# Inspector's Second Report

## CORRIB GAS PIPELINE

#### 16. GA.0004

Re-routing of the onshore upstream gas pipeline facility relating to the Corrib Gas Field Project at Glengad, Ros Dumhach, Aghoos, Bellagelly South, Co. Mayo

Figure 18: Sensitivities for the LVI (Individual Risk of a Dangerous Dose)

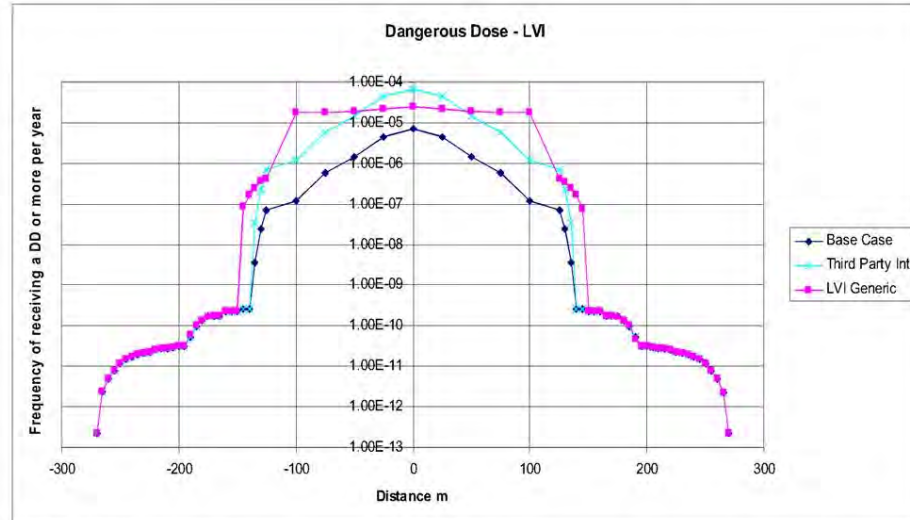
I propose to discuss Figure 18. This presents the base case risk transect for the LVI. This base case presents a similar risk transect to that shown in Figure 12 for the LVI. The generic case shown has been included and Mr. Crosswaite in his evidence outlined that this case represents a catastrophic failure of large equipment at LVI. Mr. Crosswaite further stated that no such catastrophic failure of large equipment, large flanges or large valves has been shown from North Sea comprehensive data over 16 years. Nonetheless SEPIL included this risk transect to present a case where all equipment can fail and can fail catastrophically. In this general case the risk exceeds  $1 \times 10^{-5}$  for a radius of approximately 110m of the LVI. In this failure case the risk level at the houses is of the order of  $1 \times 10^{-11}$  (not different from the base case at that distance).

Figure 18 also presents a sensitivity case for third party interference. Mr. Crosswaite explained this case as one which allocated a likelihood of failure of the LVI equipment due to third party intentional damage to be 10 times the likelihood of failure of the other causes added together.

Figure 14: Predicted Societal Risk at Glengad

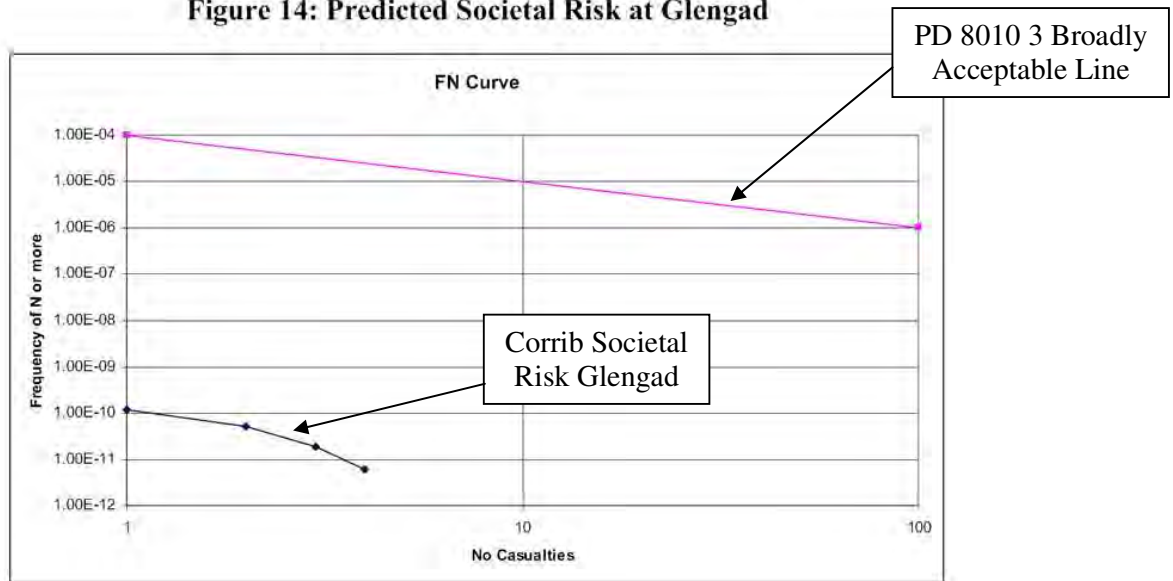
In relation to Figure 14 The Societal Risk at Glengad above, the maximum number of fatalities is associated with the maximum number of people in one house (four) and the period they would be present outdoors (since no houses fall within the piloted ignition of buildings distance persons indoors would be safe).

2. That condition (Tolerable if ALARP) applies to an area of a 63m wide circle from LVI
3. Societal Risk at Glengad is shown on Figure 14 which shows one casualty at a frequency of  $1 \times 10^{-10}$  which is a low societal risk. Mr. Wright has indicated that this societal risk is 6 orders of magnitude below the acceptance criterion line for societal risk as contained in PD 8010.

FIGURE 4 SHOWING THE STANDARDS WITH THEIR RESPECTIVE PIPELINE LOCATIONS

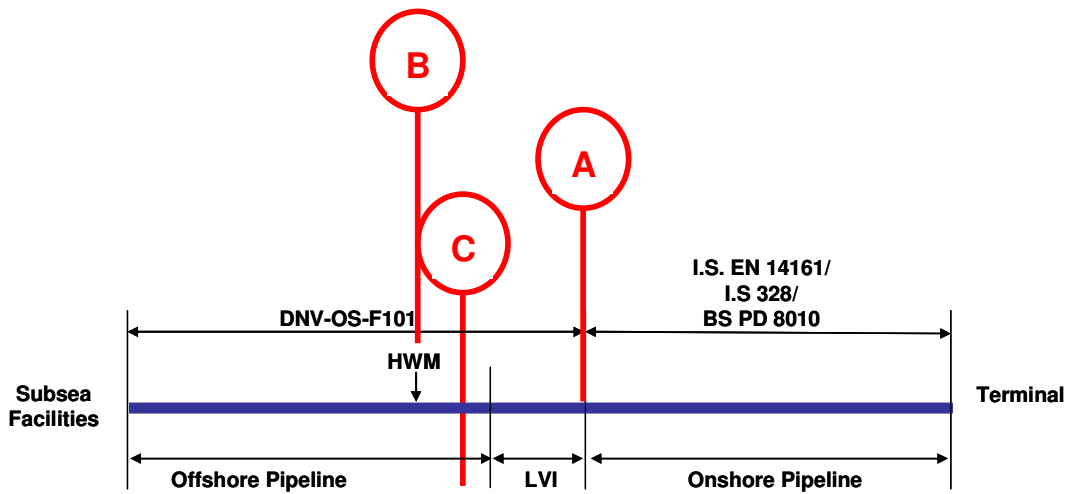
*EIS 2010 Appendix Q2.1 fig 3.1* shown below as figure 4 with my red notation is slightly misleading since the exact starting point of the onshore pipeline for planning purposes is at the high water mark(HWM) POINT B. However a section of offshore pipe is already on the beach and the onshore pipe will be welded to this section once the hydrotest has been completed POINT C while POINT A is the dividing point between the two codes.

Figure 4 ( SEPIL Fig 3.1) shows a portion of onshore pipe PRE LVI and the LVI (POINTS B-A) covered by the offshore standard DNV.OS F101, but with no mention of supplements. This again is misleading. Mr. Gurden explained during his presentation that SEPIL had intended that the supplements IS 328 and BS PD 8010 be applied to the offshore standard. This is also explained in the *EIS Appendix Q3.2 section 7 but Q3.2 - Table 4.1* again confuses the issue by not assigning the supplements to DNV-OS-F101 on the part of the chainage being discussed – HWM to downstream weld of the LVI barred exit tee (POINTS B-A).

**FIGURE 8 SHOWING THE PIPES TRANSPORTED INTO THE TUNNEL**

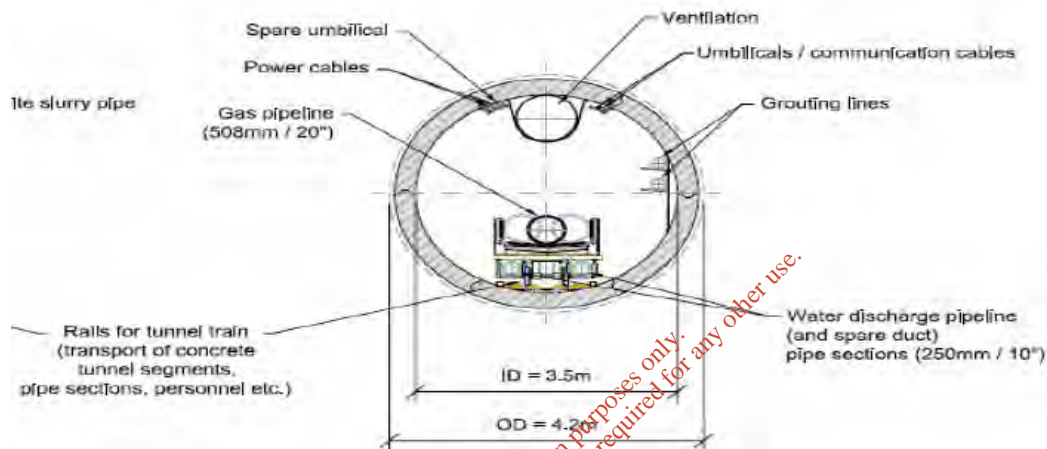
Figure 8 also shows a ventilation duct at the top of the tunnel. The Observer's were concerned that SEPIL plan to leave the duct in place after the pipeline is constructed and the tunnel is filled with grout. The fear being that this could be used at a later stage to transport other fluids. This was totally refuted by SEPIL.

FIGURE 10 SHOWS THE PREDICTED SETTLEMENT ALONG THE PIPELINE FROM AGHOOS TO THE TERMINAL FOR CASE 1

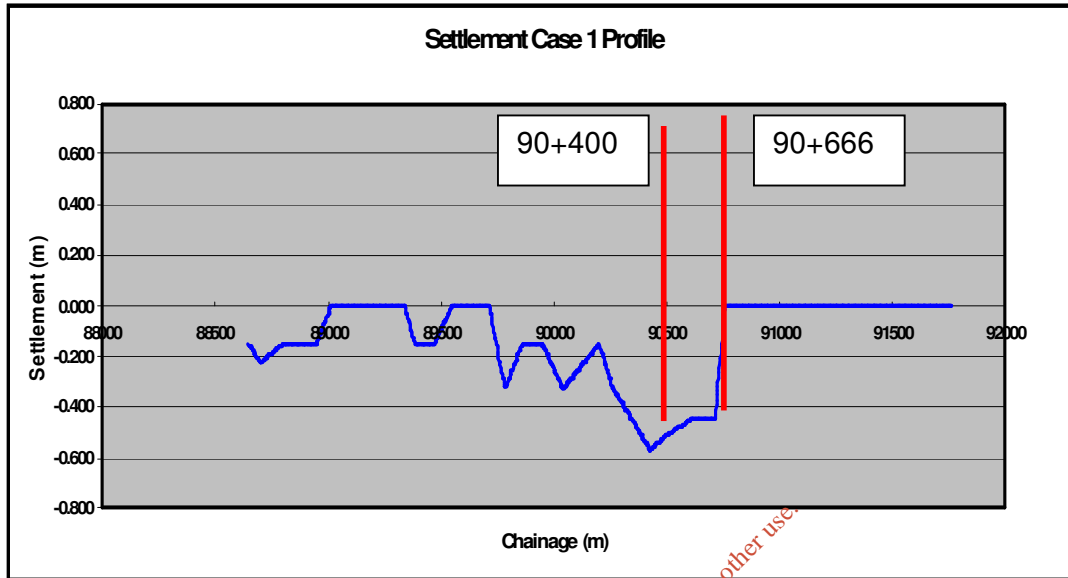
From Figure 10 there it can be seen there are two locations of high settlement at locations approximately KP 90.400 and KP 90.666. The **maximum settlement of 0.6m** was predicted at location KP 90.666.

From *Appendix Q4.1A* the maximum levels of pipe stress was predicted to occur at KP 90+770. This was due to the relatively abrupt change in settlement data as shown in Figure 10

**FIGURE 14 COMPARISON OF THE LVI LOOP AND STRAIGHT PIPEWORK INDIVIDUAL RISK TRANSECTS**

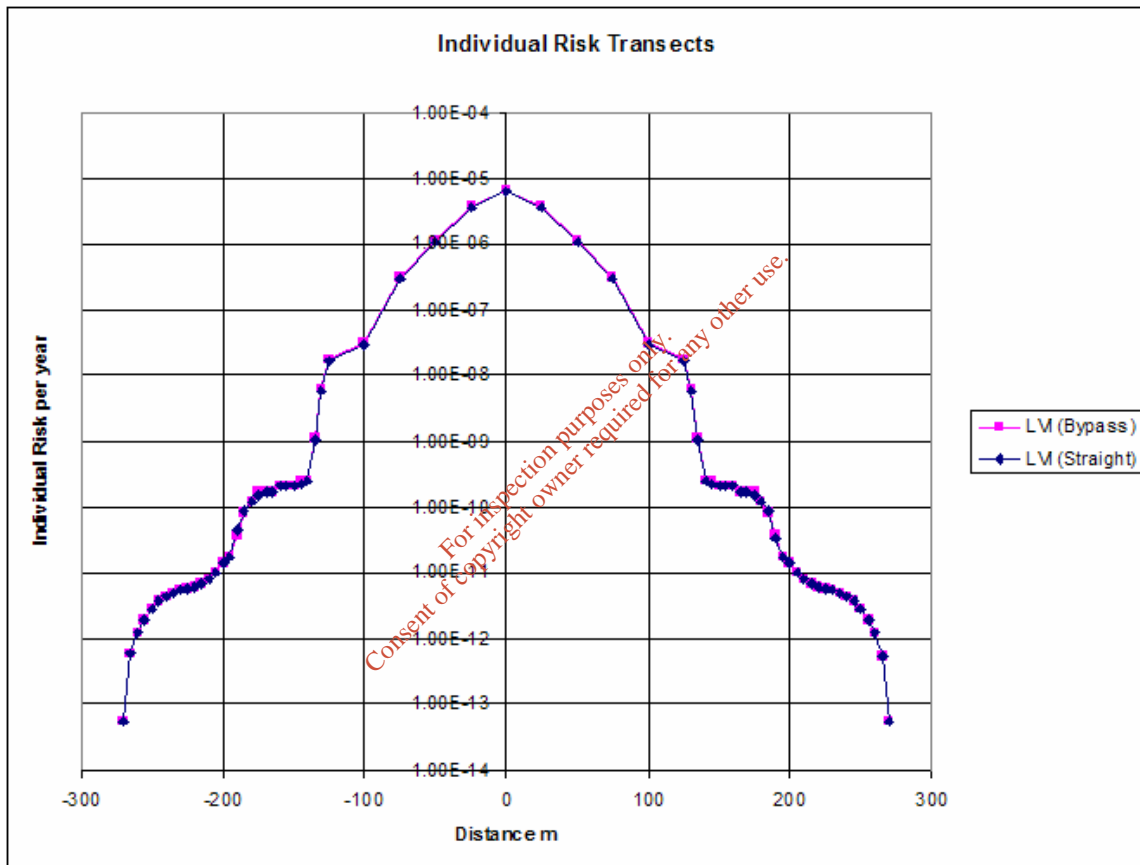
The comparison of the Individual risk transits for the two alternative pipework configurations are shown below in Figure 14 and discussed later in the report under Sections 13

FIGURE 17 SHOWS PREDICTED FLOW PATTERN MAP FOR CORRIB OPERATION

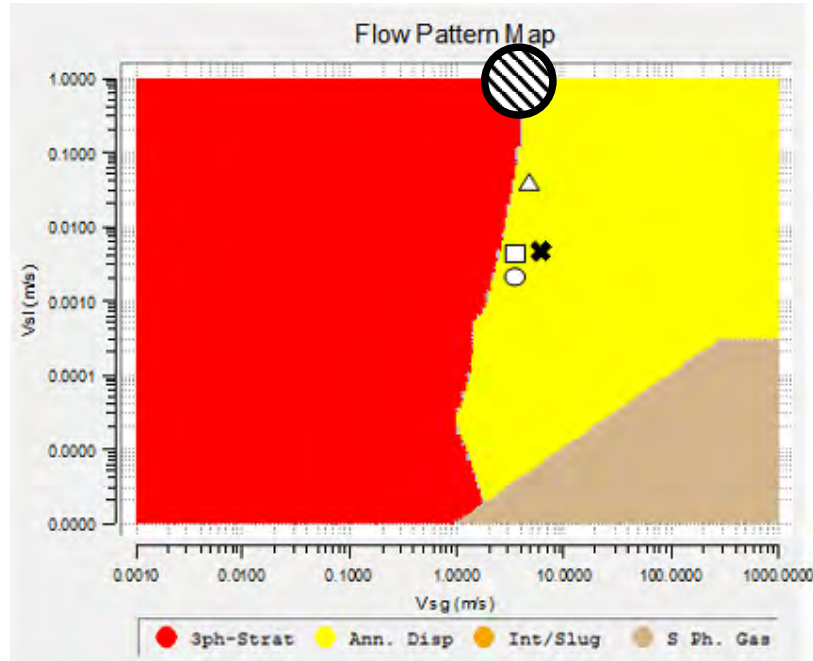
From Figure 17 SEPIL predict that the pipeline will operated in the desired annular flow regime through its entire life. However from the flow map it can be seen that the operating points are close to the red region
